The Crestview Apartments Project

Final Environmental Impact Report
SCH#2020069047

September 2021

Fig 1: Lines (pink from SCWP vista point #1; white from SCWP vista point #2) show the undisturbed line of sight over the project site to the Box Springs Mountains. The project will create a huge 50ft high complex in this otherwise undisturbed viewscape.

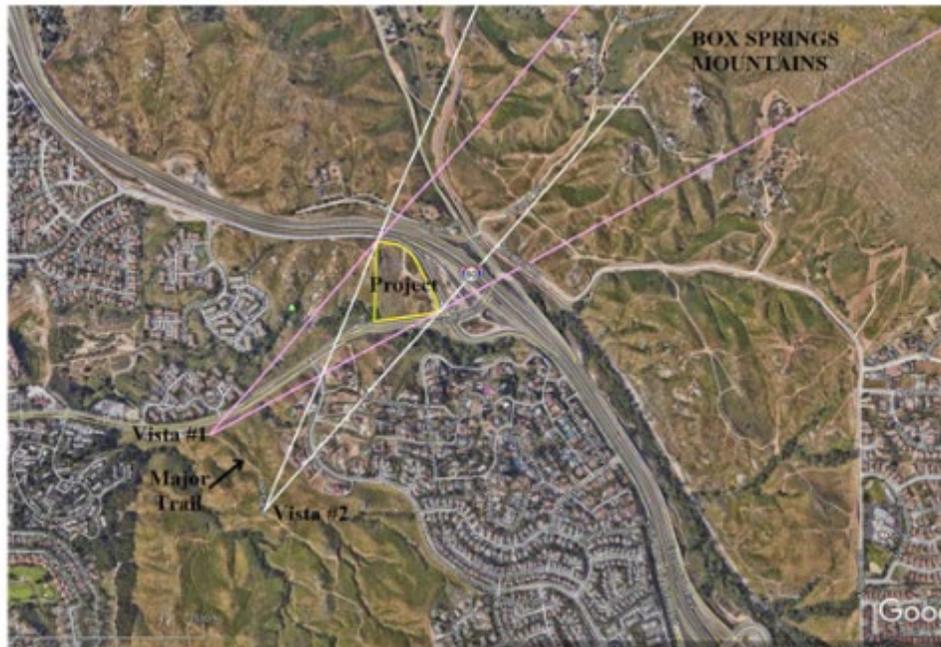
Second, the height (approximately 50ft) of these buildings is entirely inconsistent with the viewscape in the area. In particular, SCWP is a very heavily used park, with the major point of entry on Central Ave, west of the project. From the parking area, a major trail first heads up hill towards the project and then follows the high ground south (see Fig 1 map). This stretch of trail provides dramatic views of the Box Springs Mountains to the east, looking over the project site. The project will severely impact this viewscape. Part of the line of sight does cross a few, largely hidden, single story homes, but the view is otherwise entirely undisturbed by buildings.

9.8

The commenter cites DEIR Figure 5.1-5 to support the commenter’s argument of an “extreme degree of staircasing” that would impact scenic vista views. However, based upon Figure 5.1-5, the commenter’s description appears to be exaggerated and out of appropriate visual context. The view of the proposed Project’s walls and 2:1 slopes depicted in DEIR Figure 5.1-5 is provided from a relatively close-up overhead view. If Comment 9.7 is to be understood, the commenter’s concern stems from proposed Project walls and 2:1 slopes significantly impacting scenic vista views from trails in the SCWP in addition to impacting public views for those traveling/biking/exercising along Central Avenue. However, the commenter fails to provide adequate evidence or an explanation for how these impacts to public views along Central Avenue would occur other than to state the “extreme degree” of “staircasing” would have a “major impact on the landform.” As previously discussed in Response 5a.2, the proposed Project would not significantly impact public views of QROS Park from Central Avenue (refer to Response 5a.2 for a more detailed discussion). Moreover, potential impacts to scenic vista views from the SCWP due to the “extreme degree” of “staircasing” stated in reference to DEIR Figure 5.1-5 would not be as significant or “extreme” as the commenter implies. As discussed in Response 9.5, implementation of the proposed Project would not significantly impact views from SCWP of QROS Park or the mountain views beyond. Due to factors such as distance, topography, and existing development, views of the “staircasing” the commenter identifies would be far less “extreme” and exaggerated when viewed from trails within the SCW Park than the commenter alleges based on DEIR Figure 5.1-5.

Fig 4: Commercial Project to the immediate east of the project showing the inclusion of a 30ft wide buffer to encourage wildlife movement.

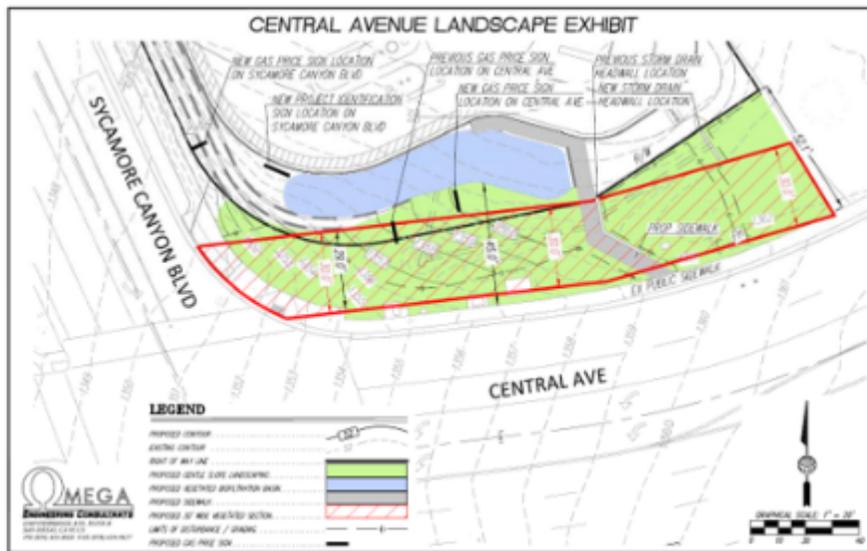
The only viable route for constrained linkage 7 appears to be from QRP along a habitat corridor following the north side of Central Ave to the Freeway underpass. The option for

such a route has already been incorporated into the design of the commercial development to the immediate east of the project. Specifically, the inclusion of a 30ft wide buffer along Central Ave with natural vegetation and minimal to no light intrusion (fig 4). In my expert opinion, it is essential that a similar 30ft (or more) buffer along Central Ave be incorporated into the project, from the western edge of the property as a continuous strip to the eastern edge at Sycamore Canyon Boulevard. This wildlife buffer should be planted with native vegetation and protected to the extent possible according to the MSHCP wildland/urban interface guidelines.
